STAFF REPORT  
KETCHUM PLANNING AND ZONING COMMISSION  
MEETING OF MAY 19, 2020

- PROJECT:** 3020 Warm Springs Rd Duplex Design Review
- FILE NUMBER:** P20-031
- APPLICATION TYPE:** Design Review
- REPRESENTATIVE:** Craig Lawrence, AIA
- PROPERTY OWNER:** Doug & Stacey Waddell
- LOCATION:** 3020 Warm Springs Road (Wills Condominium Subdivision No 2)
- ZONING:** General Residential Low Density (GR-L) Zoning District
- NOTICE:** A public hearing notice for the project was mailed to all owners of property within 300 feet of the project site on April 29<sup>th</sup>, 2020.
- REVIEWER:** Abby Rivin, Associate Planner

**NEW DUPLEX**

**A-04**

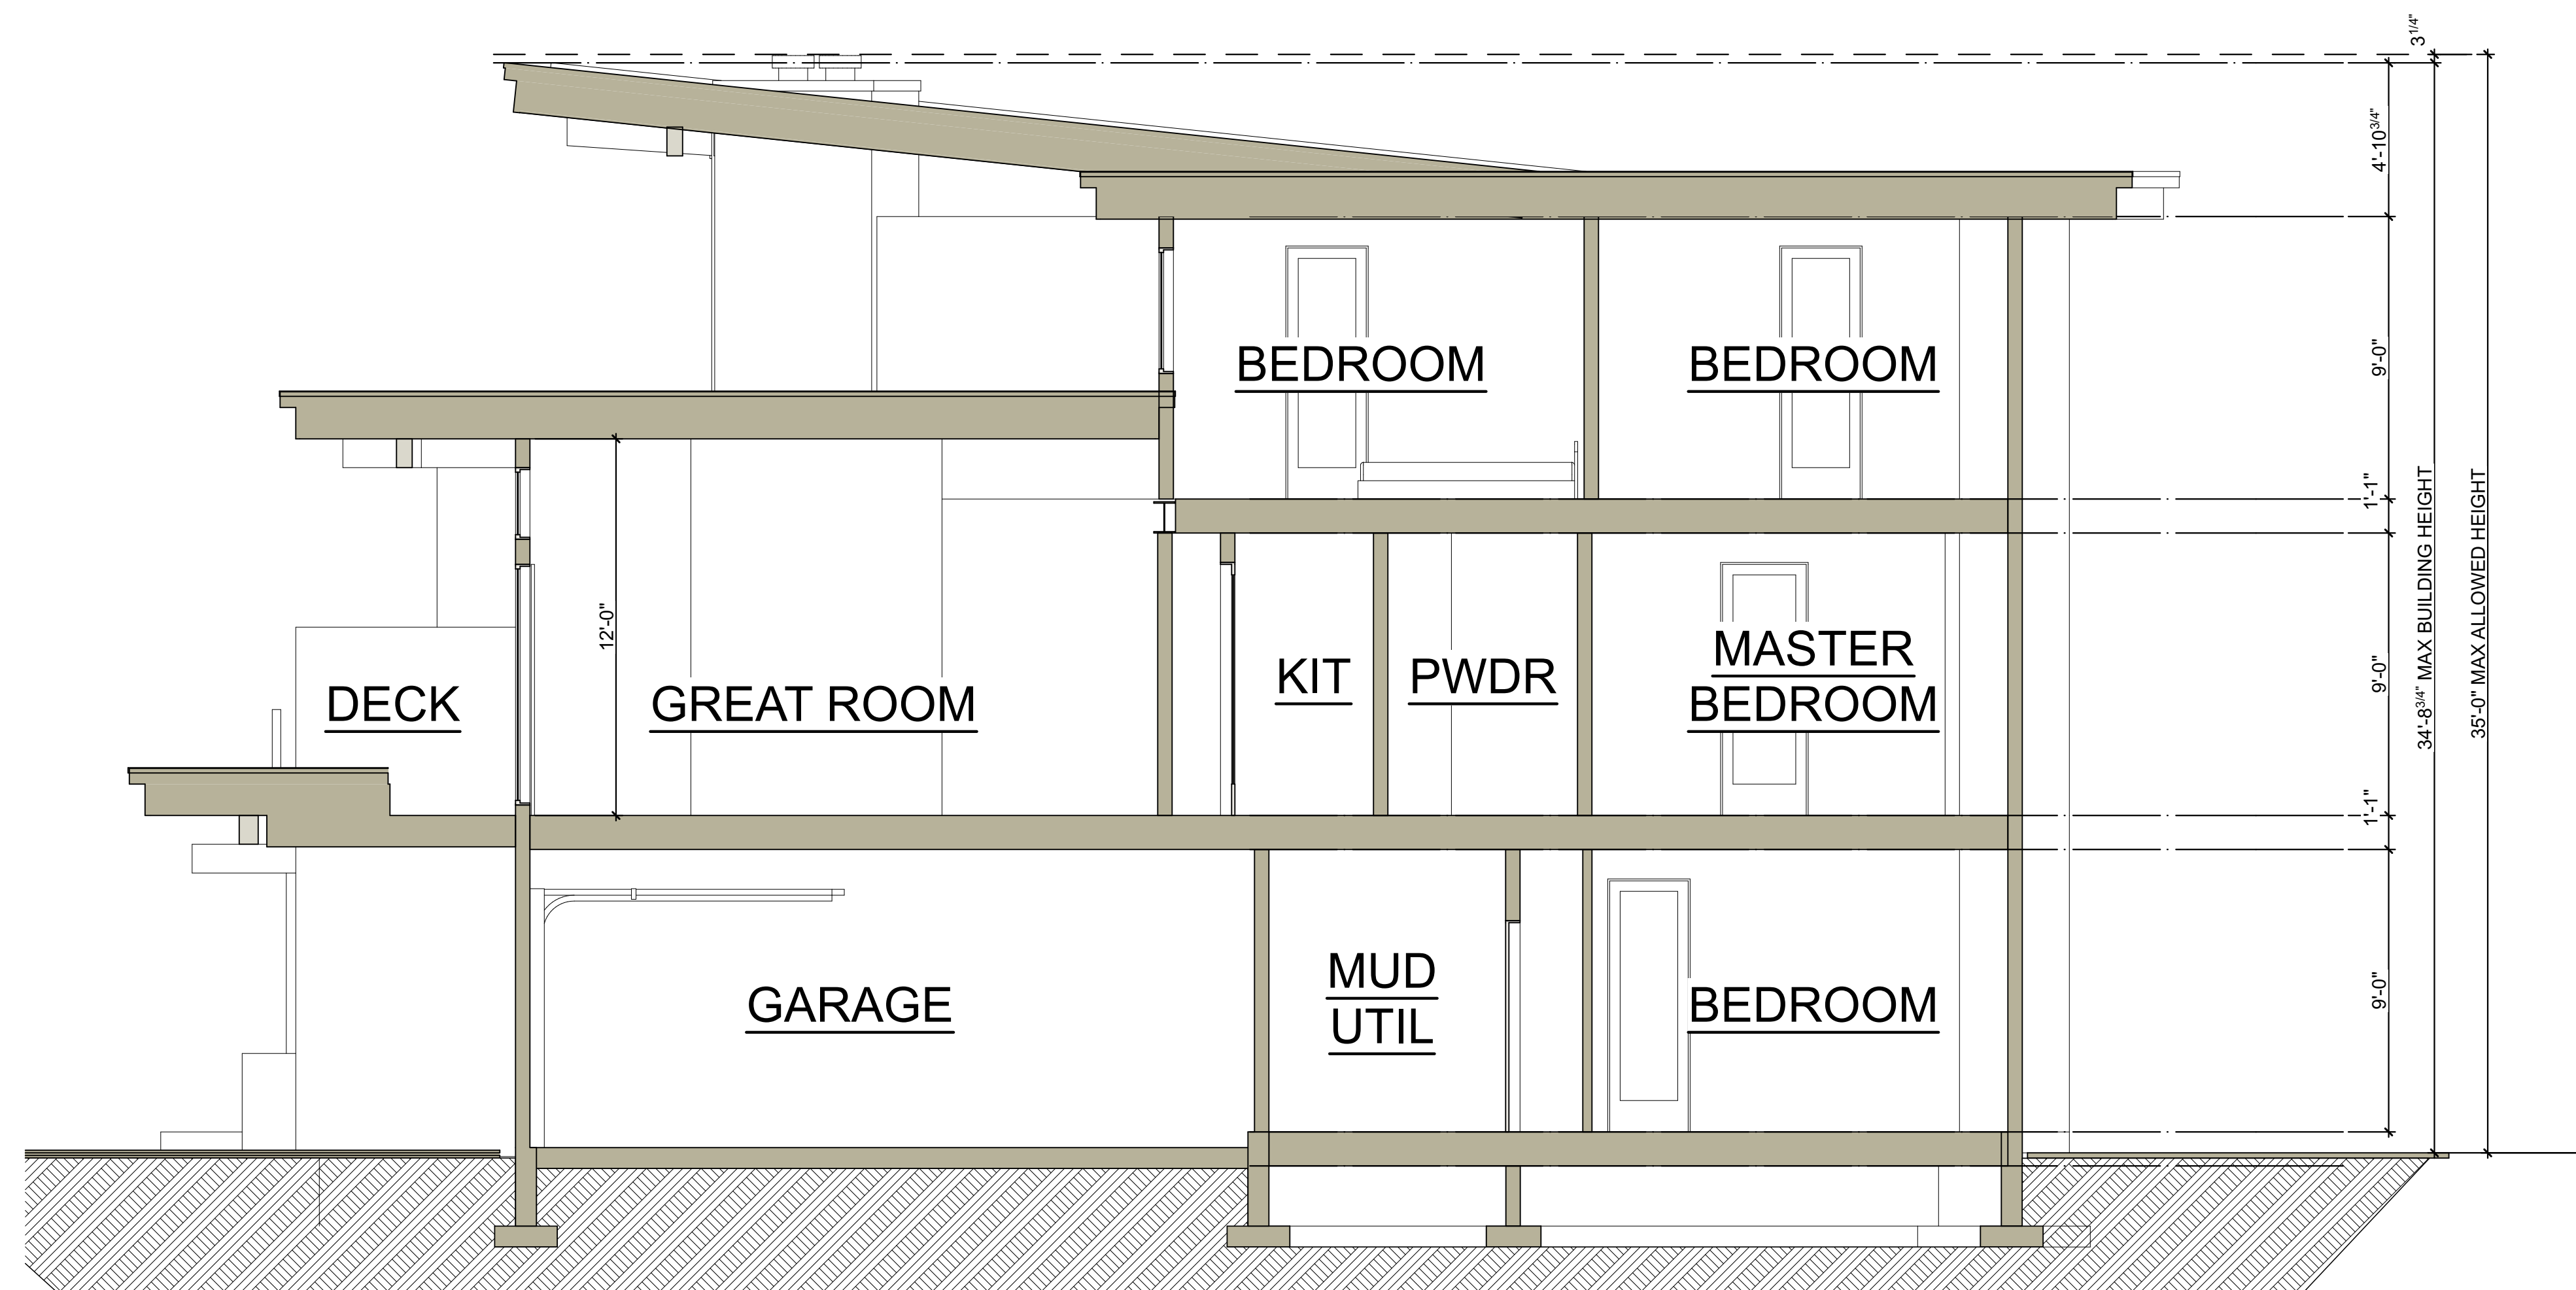
Building elevations are included on Sheets A-03 and A-04 of the project plans. The three floors are horizontally stacked on top of each other as one-story elements separated by a border of black fascia. The lack of sufficient vertical, two- or three-story elements incorporated into the façade design exacerbates the appearance of flatness.

Rectangular window and door openings break up the solid, gray stucco walls across each façade. The front façade is characterized by the extensive glass used for the window and door treatments. The stone veneer chimney separating the townhome units is the only vertical, three-story element that grounds the building to the project site. The slight butterfly angle of the roof reduces the box-like appearance of the building.

<input checked="" type="checkbox"/>	<input type="checkbox"/>	<input type="checkbox"/>	17.96.060.F5 Architectural	<p>Building walls shall provide undulation/relief, thus reducing the appearance of bulk and flatness.</p>
			<b>Staff Comments</b>	The front façade is defined by rectangular windows and doors. The three floors are separated by thick borders of black fascia. The garage doors and second-floor balcony provide relief from the significant glazing. Projecting between the townhome units, the stone veneer chimneys separate the townhome units. The side and rear façade are comprised primarily of gray stucco with windows. The roof covering at the entryway as well canopy elements decrease the stacked

**Design Review Staking Plan**

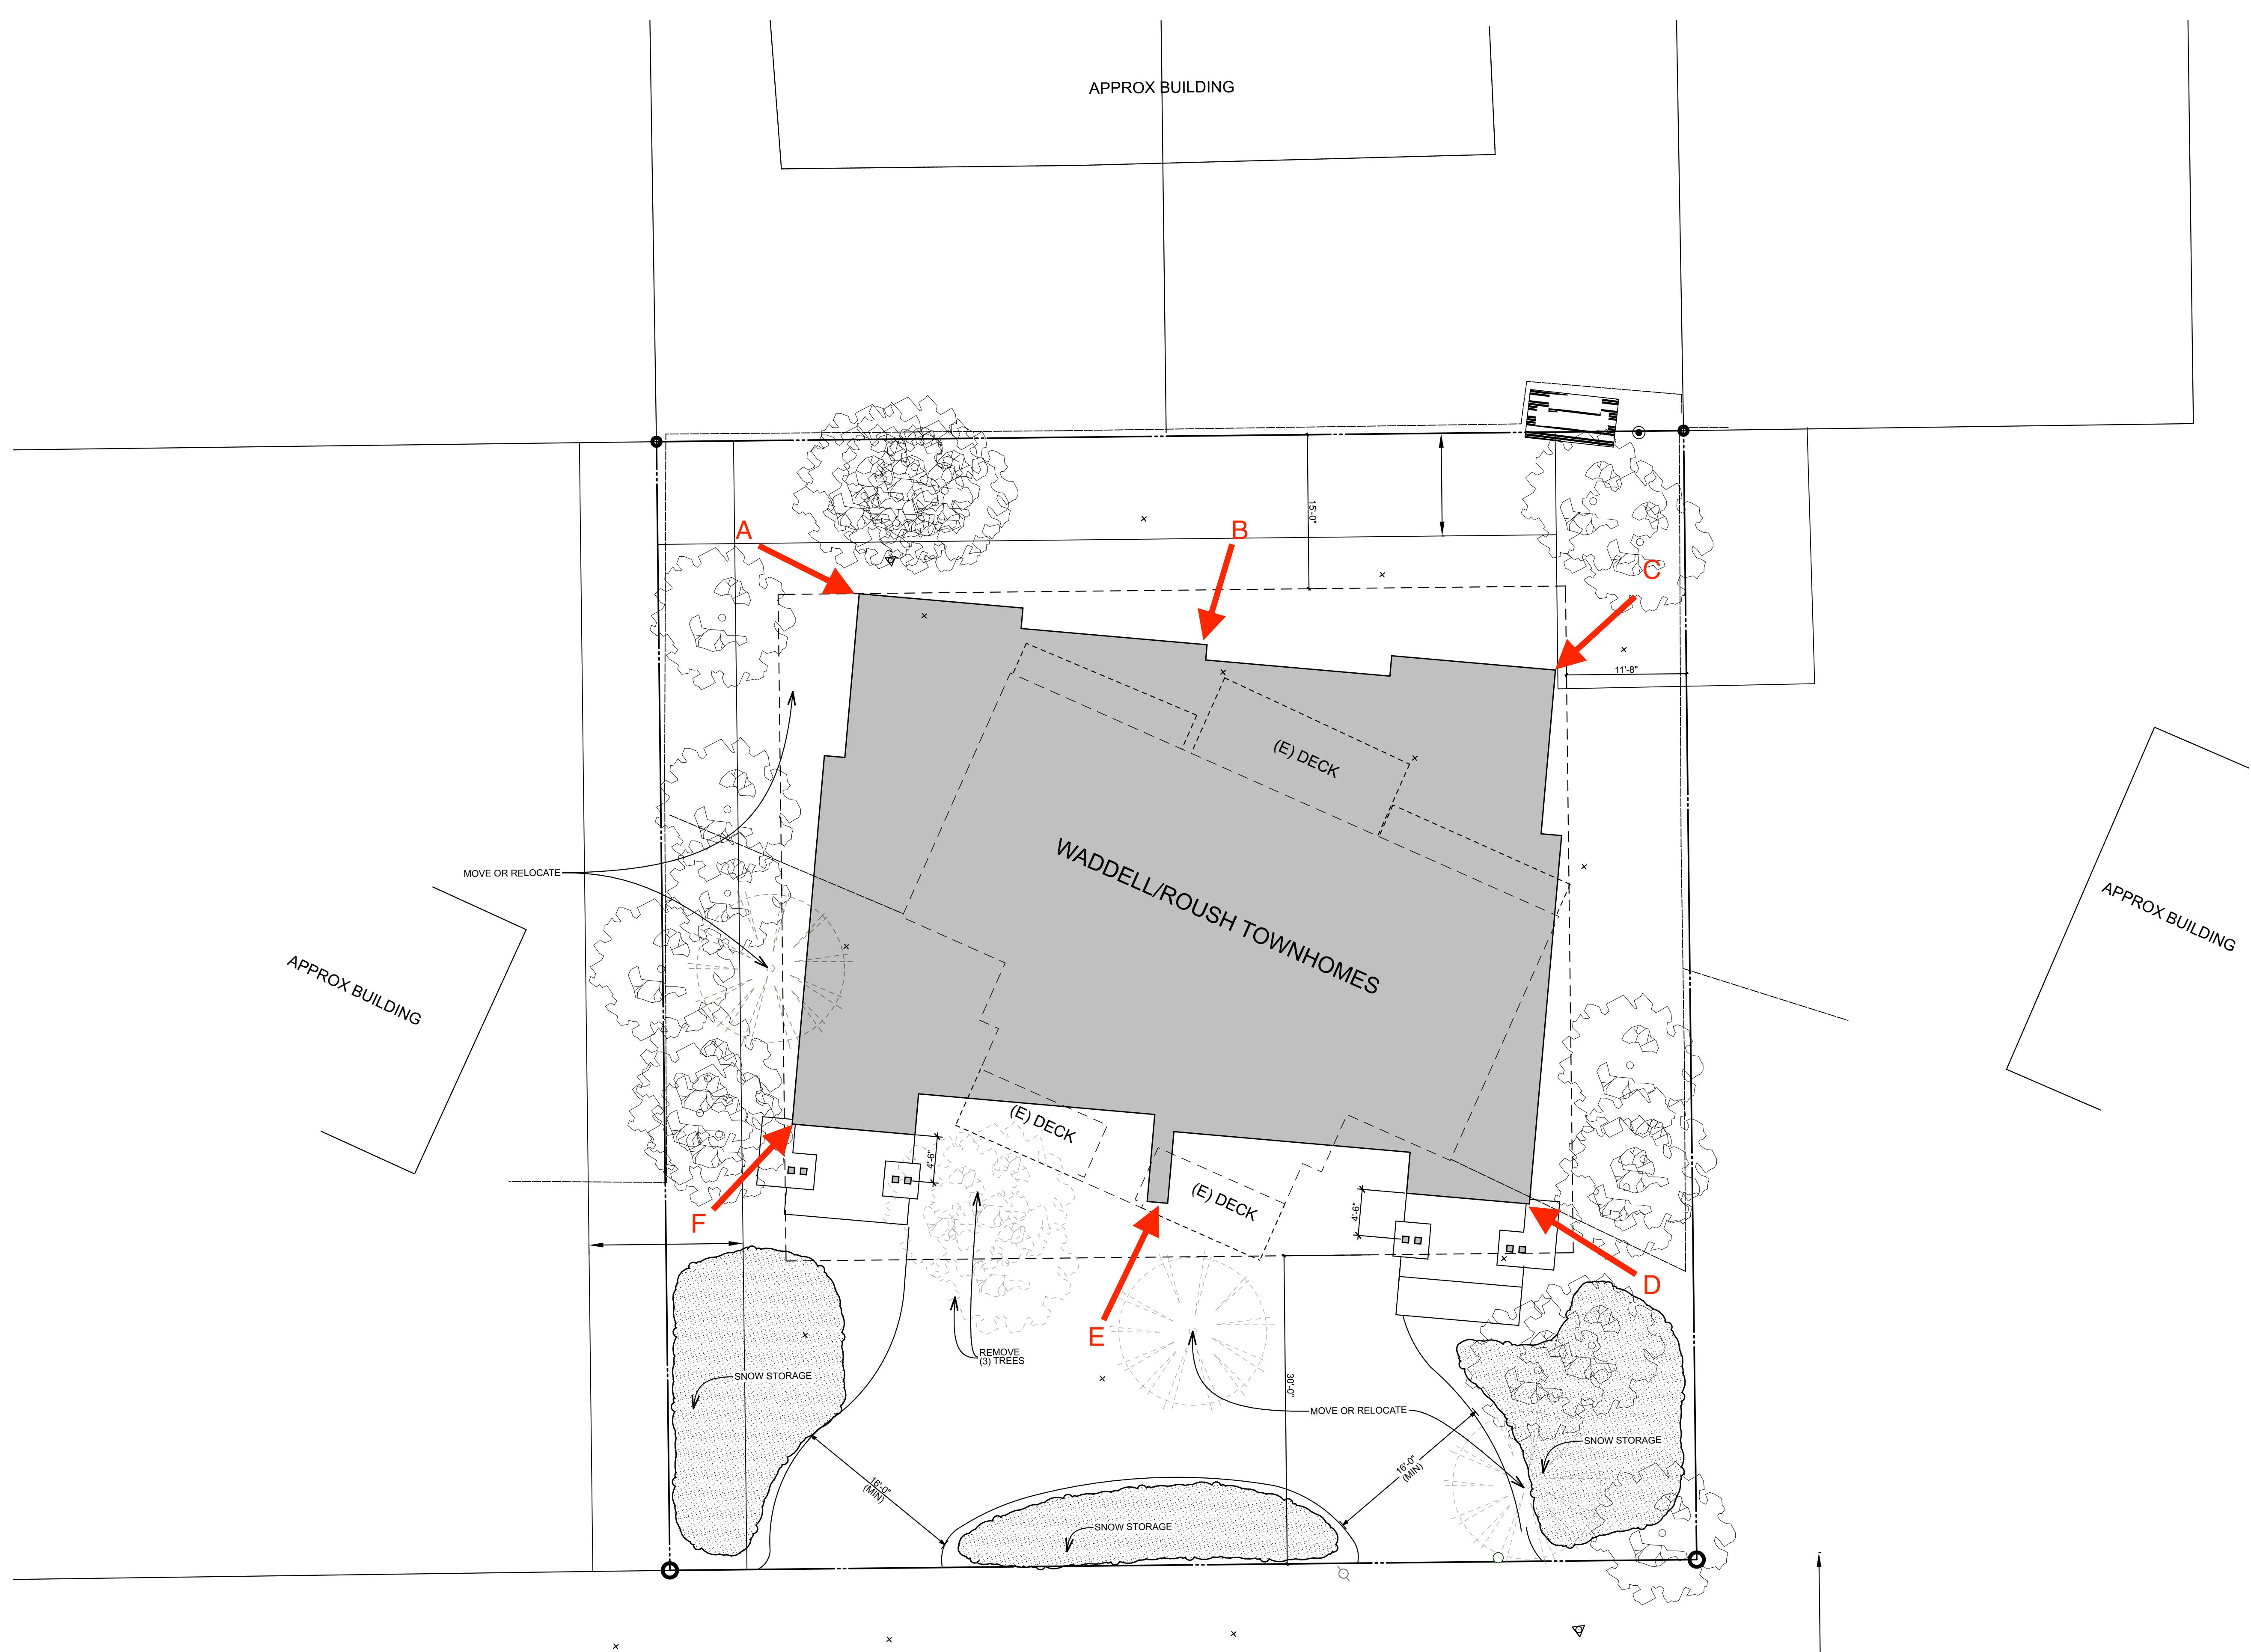
The project plans indicate that existing vegetation will be retained on the property and no additional landscaping has been proposed. Staff recommends the applicant consider adding landscaping to soften the duplex's rectangular mass, provide visual relief from building walls, and screen the townhomes from the street and neighboring homes.

<input checked="" type="checkbox"/>	<input type="checkbox"/>	<input type="checkbox"/>	17.96.060.H2 Snow Storage	Snow storage areas shall be provided on-site.
			<i>Staff Comments</i>	<i>Three snow storage areas are indicated on Sheet A-01. See Staff analysis for KMC §17.96.060.H1.</i>
<input checked="" type="checkbox"/>	<input type="checkbox"/>	<input type="checkbox"/>	17.96.060.H3 Snow Storage	A designated snow storage area shall not have any dimension less than five (5') feet and shall be a minimum of twenty-five (25) square feet.
			<i>Staff Comments</i>	<i>The dimensions of the snow storage areas must be indicated on the project plans. Snow storage areas must be at least 30% of the improved parking and circulation areas.</i>
<input type="checkbox"/>	<input type="checkbox"/>	<input checked="" type="checkbox"/>	17.96.060.H4 Snow Storage	In lieu of providing snow storage areas, snow melt and hauling of snow may be allowed.

<i>Staff Comments</i>	<i>Sheet A-01 indicates that existing landscaping will be retained on the property.</i>  <i>Staff recommends additional landscaping to soften the duplex's rectangular mass, provide relief from the building walls, and screen the townhome development from the street and neighboring homes.</i>
<input type="checkbox"/>	<input type="checkbox"/>	<input checked="" type="checkbox"/>	17.96.060.J1 Public Amenities	Where sidewalks are required, pedestrian amenities shall be installed. Amenities may include, but are not limited to, benches and other seating, kiosks, bus shelters, trash receptacles, restrooms, fountains, art, etc. All public amenities shall receive approval from the Public
